Planning Commission Staff Report

Subject: Change of Zoning Vote Report

Petition: **P.Z. 10-2013 Schoettler Grove (2349 Schoettler Rd.)**

RE: P.Z. 09 & 10-2013 Schoettler Grove

SHEET NO.: **C1.1**

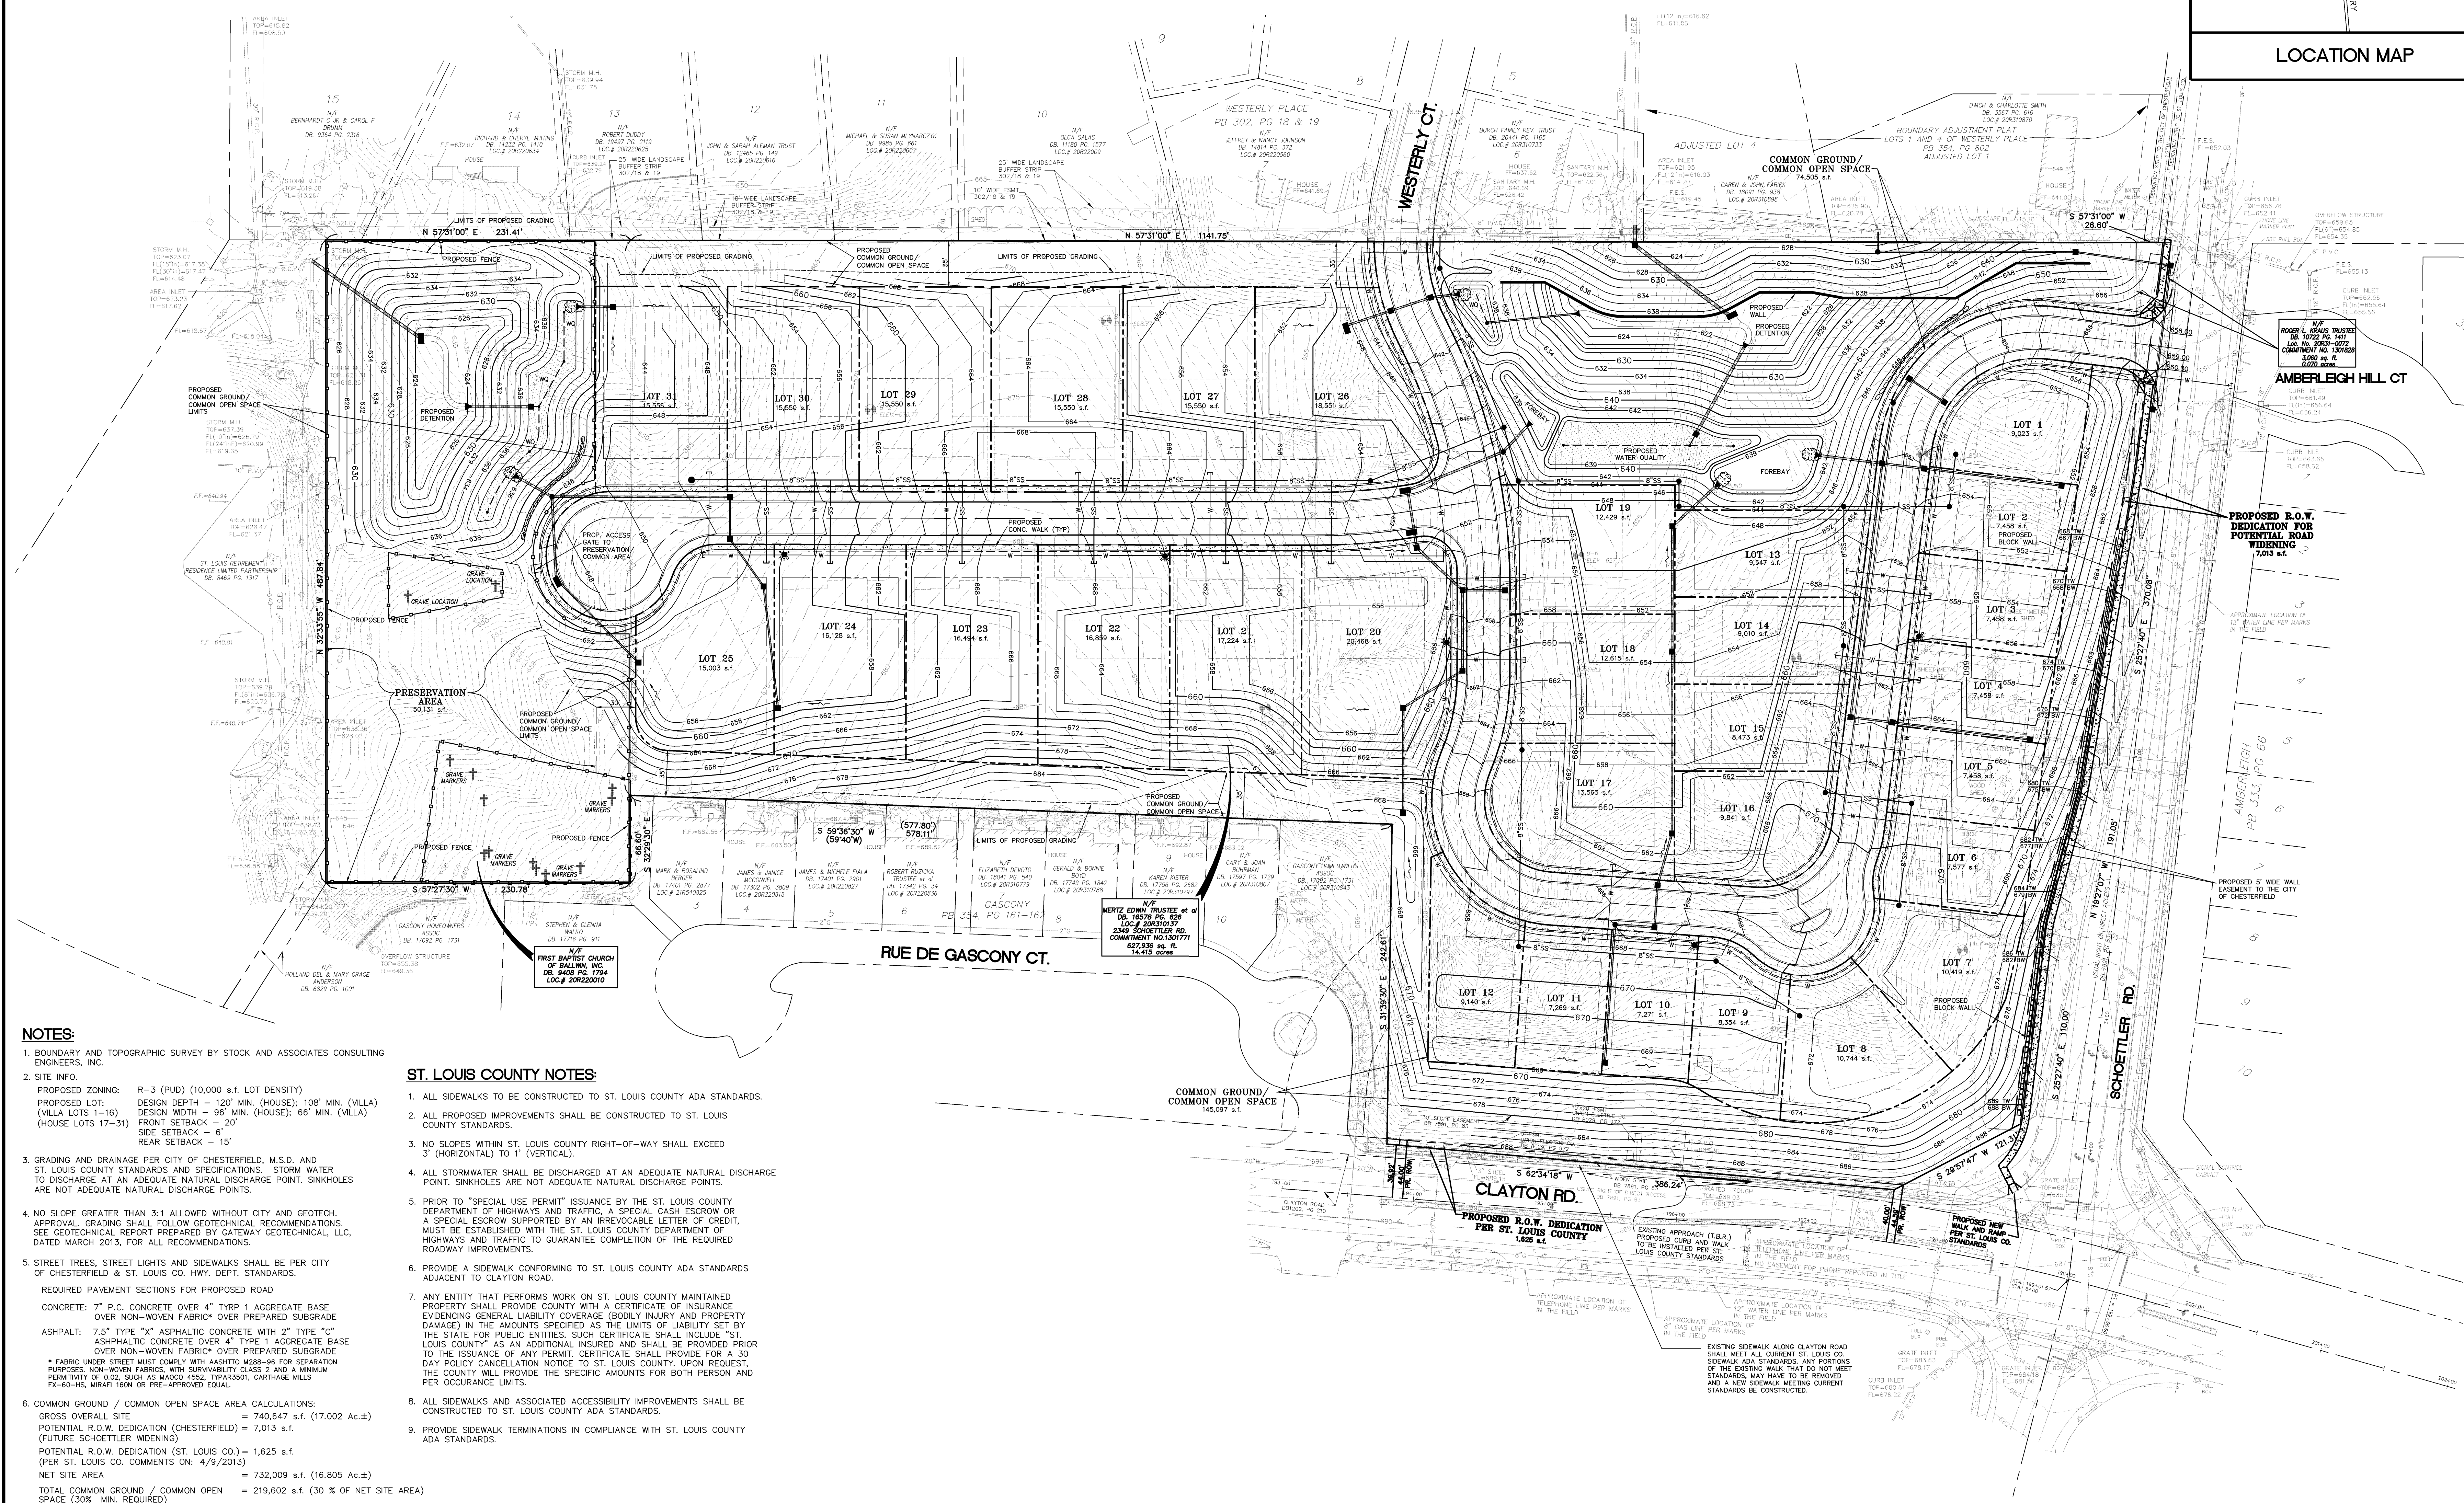
1. There is still a concern regarding the amount of existing landscaping and removal of natural buffering (berming) along the northern boundary of Schoettler Grove with Westerly Place. What additional steps can be taken to preserve the existing vegetation and berm and provide enhanced landscaping from what is currently proposed? What steps will be taken to create a visual buffer and separation between Schoettler Grove and Westerly Place so that individuals and residents know when they are leaving one subdivision and entering another?

3. What preservation efforts can be taken to preserve additional tree massing throughout the site above what is currently projected to be preserved (specifically on the eastern section)?

1. Remove the trail within the Preservation Area of the plan.

2. Currently the property located at 2297 Schoettler Road accesses the property from a driveway off of Schoettler Road. Provide on the preliminary plan a note that indicates if in the future this site redevelops, that cross access to this parcel from Schoettler Grove development could be achieved if directed by the City of Chesterfield.

As you are aware, Petitioner's development team has looked at a number of versions of a plan, and the revised Preliminary Plan submitted today represents substantial changes from the original submitted Preliminary Plan. Those changes were made to address the buffering and separation concerns. Since the last Planning Commission meeting, Petitioner's development team has looked at these concerns again. Further changes are not feasible or permissible because of the City's slope requirements and the topography of the site.

However, with respect to the separation concern, Petitioner has consistently maintained that a full access connection at Westerly Court is not necessary from Petitioner's perspective. Consequently, Petitioner would propose that Attachment A be amended to provide that the Westerly Court connection access be limited to emergency and street maintenance access purposes only, and Petitioner will install an appropriate gate and opening mechanism as directed by the Fire District and the City.

As stated in the response to No. 1 above, Petitioner's development team took another long look at this concern, but further changes in this area are not feasible or permissible because of the City's slope requirements and the topography of the site.

The trail is not shown on the revised Preliminary Plan.

The Petitioner agrees, and the note is on the revised Preliminary Plan.

SHEET NO.:
C1.2

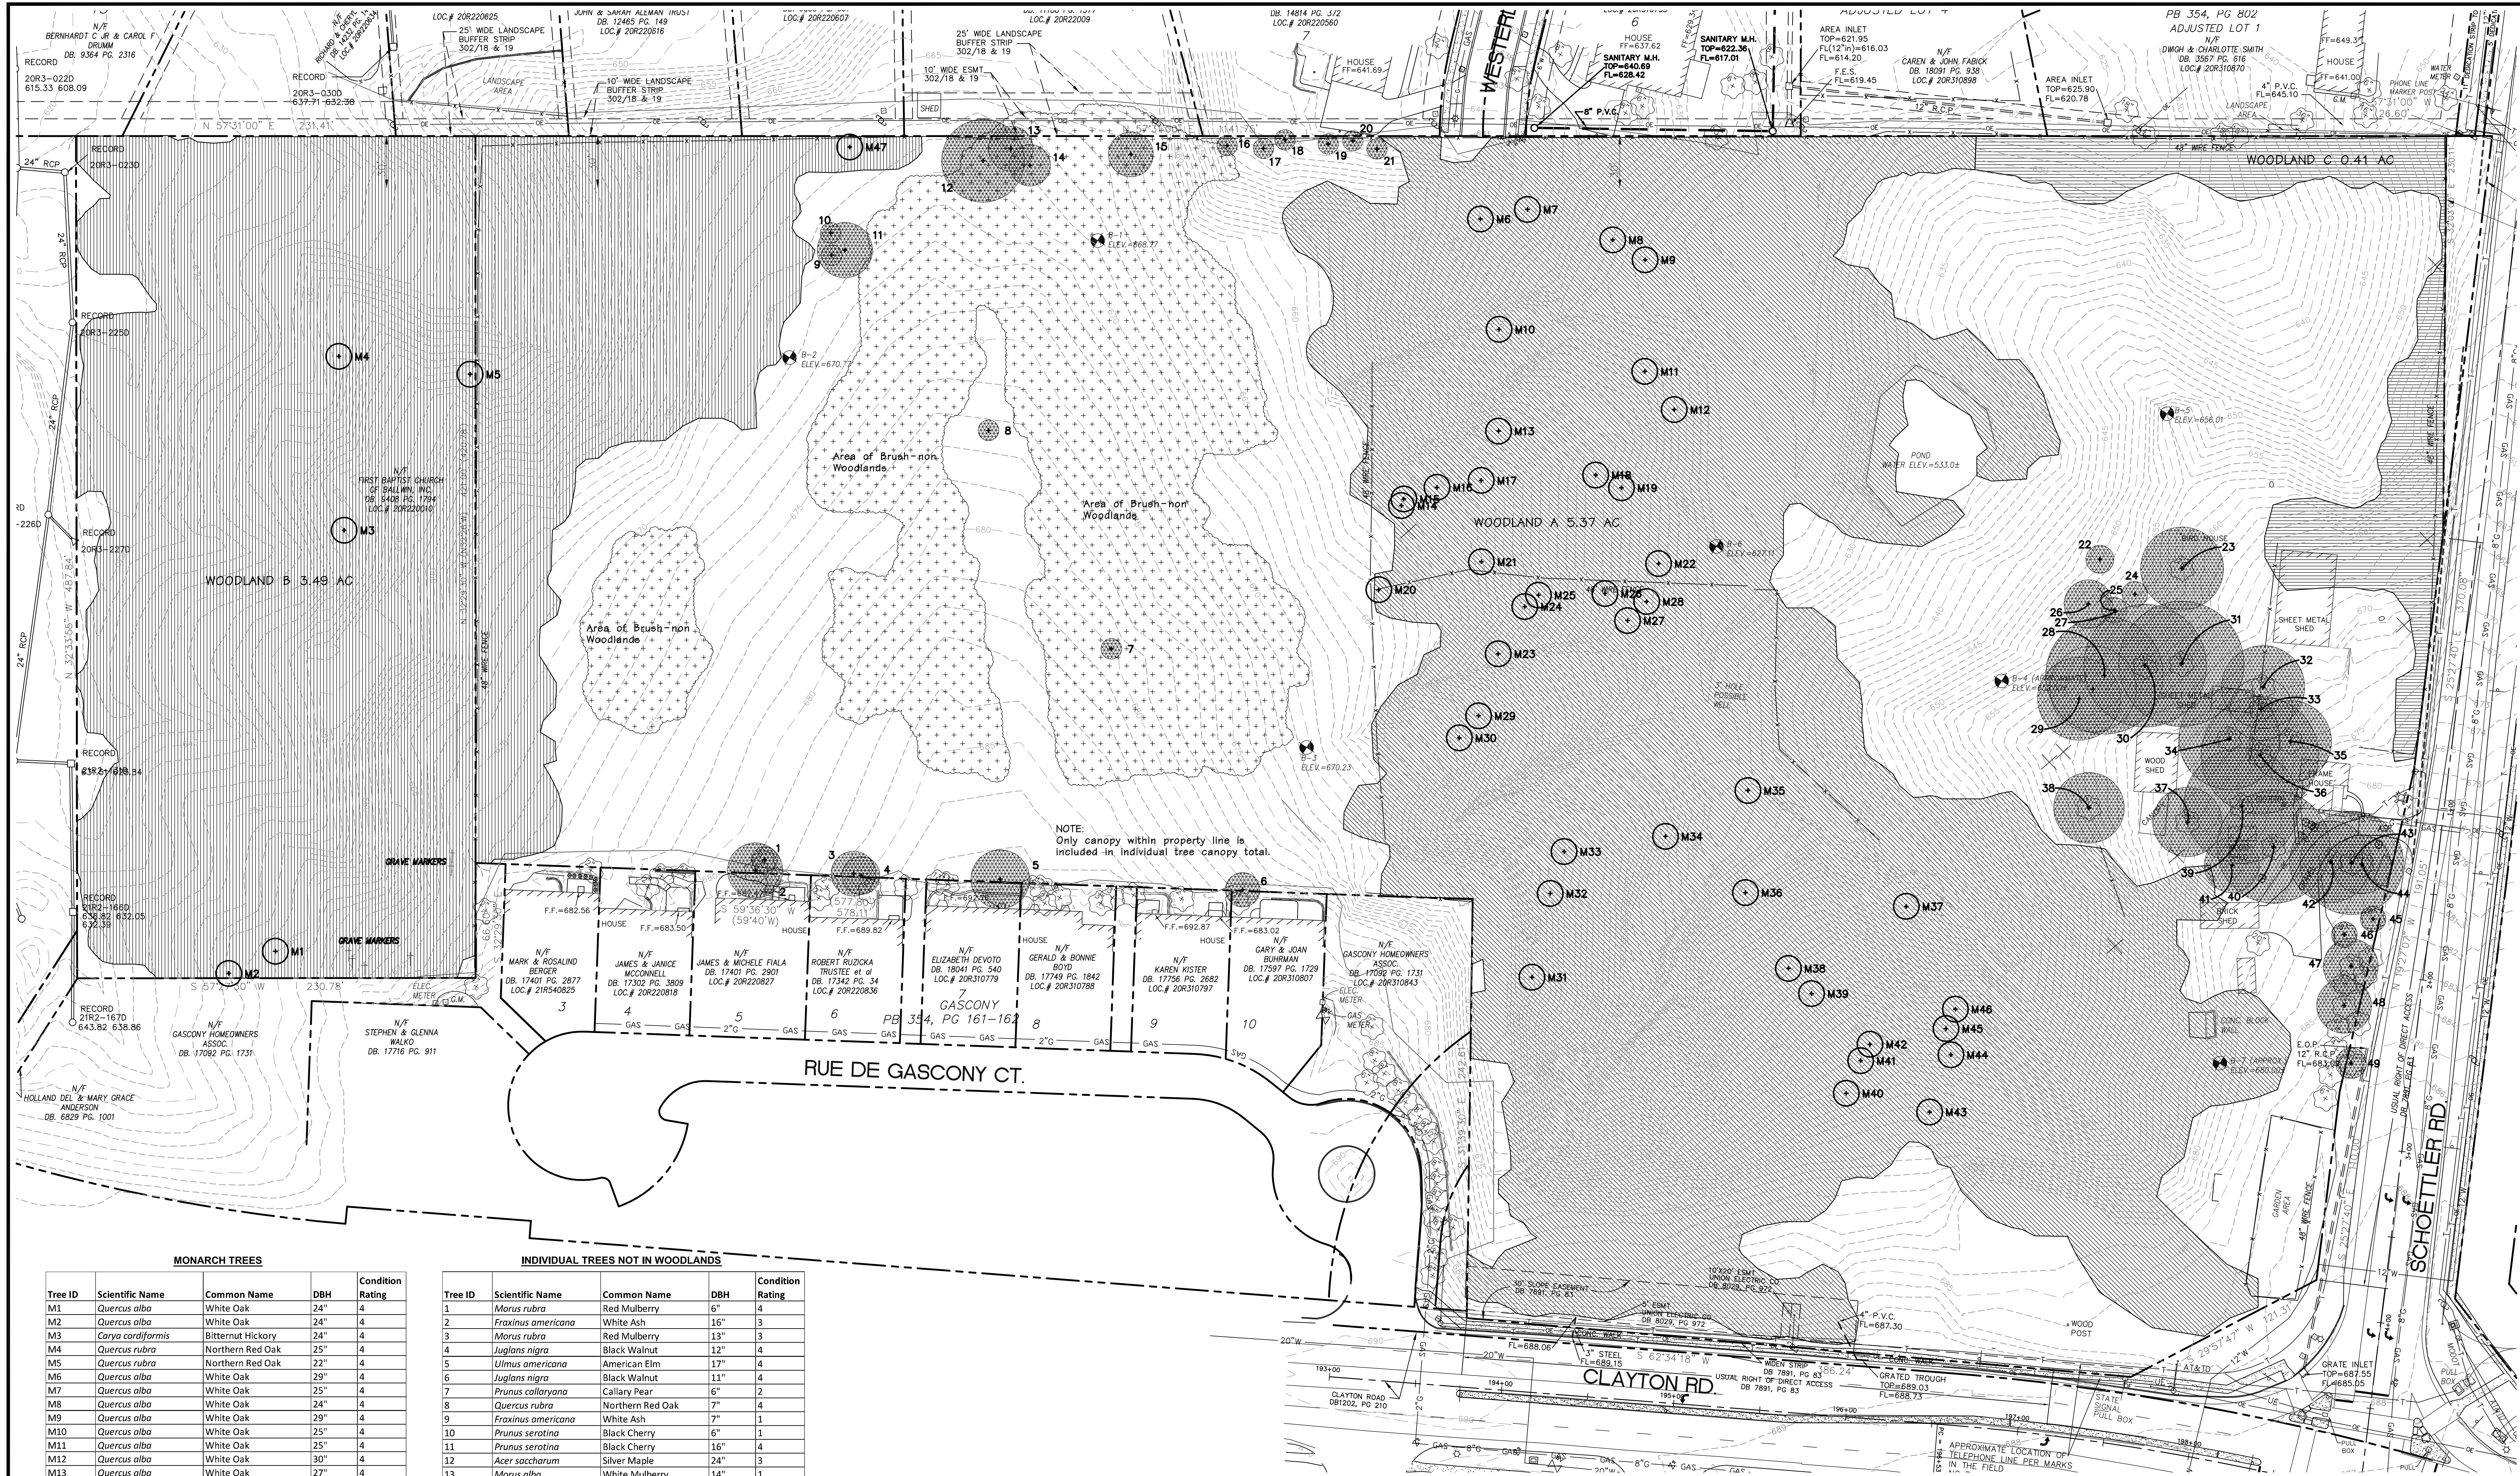
All of the proposed plans to date show Westerly Court extending into Schoettler Grove, however, a precedence for separating subdivisions is evident all along Schoettler Road. **We request the City of Chesterfield to keep Westerly Court as it is, with no changes.** However, if the City of Chesterfield **must eliminate the stub, we believe a cul-de-sac** at the end of Westerly Court would: 1) eliminate increased traffic, 2) keep the two differently zoned subdivisions separate and 3) enhance the visual buffer all parties favor.
